UNITED STATES PATENT AND TRADEMARK OFFICE

APPLICATION NO.	FILING DATE	FIRST NAMED INVENTOR	ATTORNEY DOCKET NO.	CONFIRMATION NO.
	10/811,031	03/26/2004	Xiaodong Jin	MP0358	1354
	26200 73	590 11/06/2006		EXAM	INER
FISH & RICHARDSON P.C. P.O BOX 1022				BAUER, SCOTT ALLEN	
		IS, MN 55440-1022		ART UNIT	PAPER NUMBER
				2836	
				DATE MAILED: 11/06/2006	5

Application No.	Applicant(s)			
	10/811,031	JIN ET AL.			
Office Action Summary	Examiner	Art Unit			
	Scott Bauer	2836			
The MAILING DATE of this communication apperiod for Reply	opears on the cover sheet w	ith the correspondence address			
A SHORTENED STATUTORY PERIOD FOR REP WHICHEVER IS LONGER, FROM THE MAILING I Extensions of time may be available under the provisions of 37 CFR 1 after SIX (6) MONTHS from the mailing date of this communication. If NO period for reply is specified above, the maximum statutory perior Failure to reply within the set or extended period for reply will, by statuany reply received by the Office later than three months after the mail earned patent term adjustment. See 37 CFR 1.704(b).	DATE OF THIS COMMUNION (1994). 136(a). In no event, however, may a red will apply and will expire SIX (6) MONUTE, cause

FIG. 1

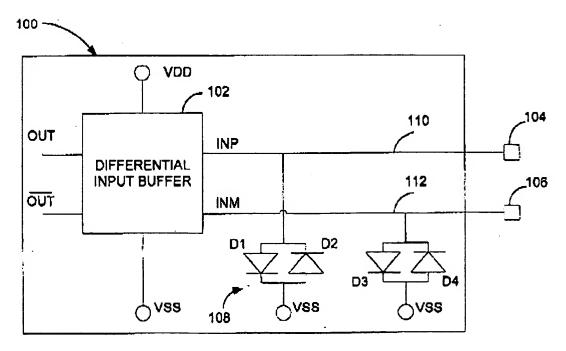
With regard to Claim 1, Jenkins et al., in Figure 1, discloses a low noise amplifier (100), comprising: a radio frequency input (104); and an electrostatic discharge protection circuit including (108), a pair of diodes (D1 & D2) each having a first and a second terminal; a first diode (D1) of the pair having a first terminal coupled to the radio frequency input (104) and a second terminal directly coupled to a first supply (VSS); a second diode (D2) of the pair having a second terminal coupled to the radio frequency input (104) and a first terminal directly coupled to the first supply (VSS); the electrostatic discharge protection circuit operable to shunt electrostatic discharge current during positive and negative electrostatic discharge events away from the radio frequency input and through the first supply (column 3 lines 34-53).

Jenkins et al. does not teach a separate electrostatic discharge clamp directly coupled between a high voltage supply and a low voltage supply so as to provide a discharge path there between during an electrostatic discharge event.

With regard to Claim 9, Jenkins et al., in Figure 1, discloses a low noise amplifier (100), comprising: receiving means for receiving an RF input (104); and shunting means (108) including, a pair of diode means (D1 & D2) each having a first terminal and a second terminal; a first diode means (D1) of the pair having a first terminal coupled to the receiving means and a second terminal directly coupled to a first supply; a second diode means (D2) of the pair having a second terminal coupled to the receiving means and a first terminal coupled directly to the first supply; and the shunting means for shunting electrostatic discharge current during positive and negative electrostatic discharge events away from the receiving means and through the first supply (VSS) (column 3 lines 34-53).

Jenkins et al. does not teach a separate electrostatic discharge clamp directly coupled between a high voltage supply and a low voltage supply so as to provide a discharge path there between during an electrostatic discharge event.
